Cargo Movement Operations System (CMOS)

Review of Software Requirements
Specification (Revised Preliminary)

8 November 1989

Contract Number F11624-88-D-0001/6K12
CDRL #A004-09

ATTACHMENT ONE. BALANCED DATA FLOW
DIAGRAM EXAMPLE

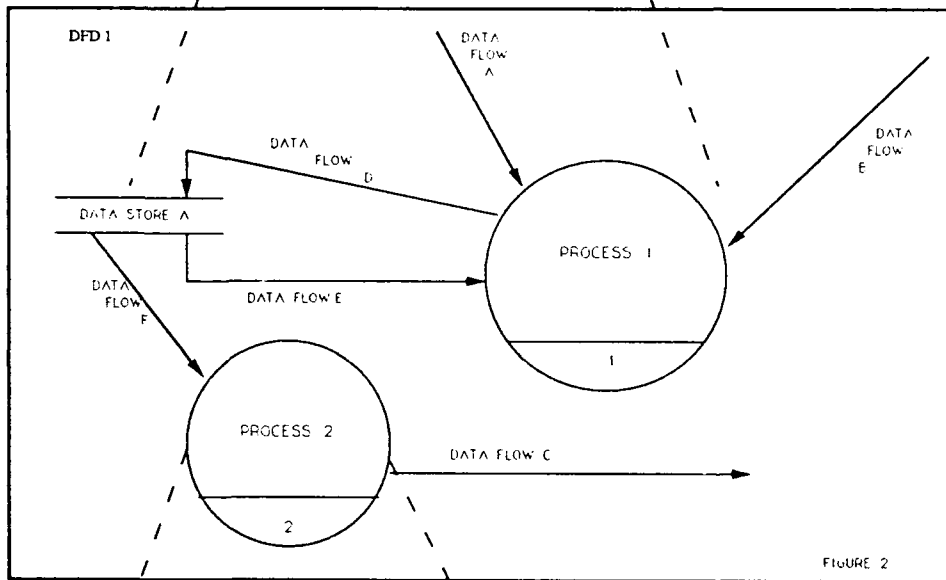
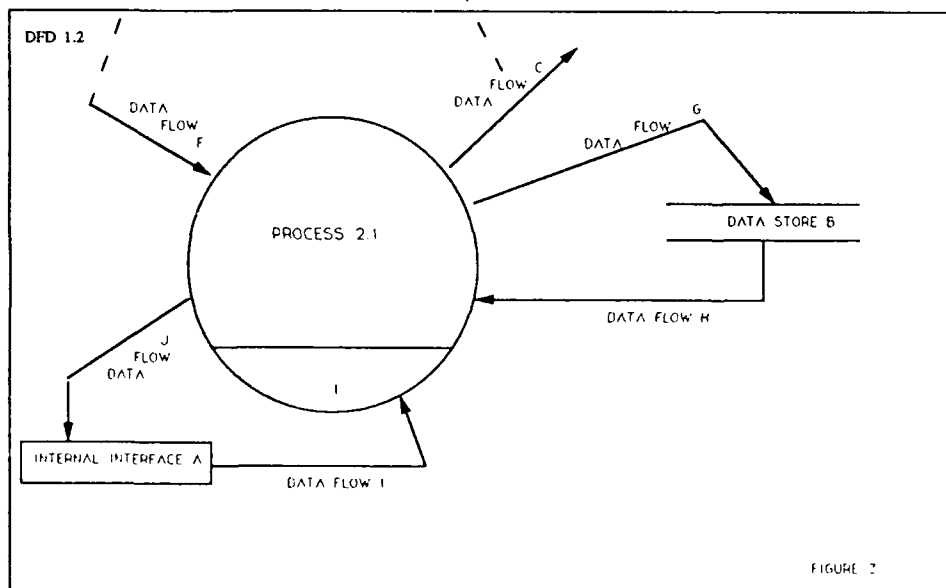
COMMENT OR RECOMMENDED CHANGE: Each external interface should be identified in a rectangle with the associated inputs and outputs. The relationship should be depicted first in a single circular blow-up of CMOS represented as DFD 0. Each system capability (SC) beginning with System Administration and its associated data flows and data stores, should be rendered in DFDs that are numbered 1., 1.1, 1.2, 1.3, etc. The context diagram at Attachment One is provided as an example.

DFD 1 does not logically decompose into DFD 1.1 and the subsequent diagrams, because the standard DFD conventions have not been used. Tracing the allocated requirements through the DFD's is a difficult task due to their disjointed presentation.

The following comment which was submitted during review of the SSDD (figure E-5 on page E-5) also applies to this Data Flow Diagram (DFD). Data flows into and out of a process should balance with the flows of that process. For example, in figure 3.2.1.1, the process "Initialize CMOS" has one inflow and two outflows. Therefore, Figure 3.2.1.1.1 should have two outflows and one inflow. All other flows should begin and end within figure 3.2.1.1 (in a circular fashion). It appears that underlying processes are not represented. Each process should be balanced with its respective exploded view. As all the requirements become allocated to the lower level capabilities, it becomes increasingly difficult to view the processes in the DFDs as anything more than separate, self-contained entities. This comment applies to all DFDs in the Applications CSCI. Please reference Attachment One.
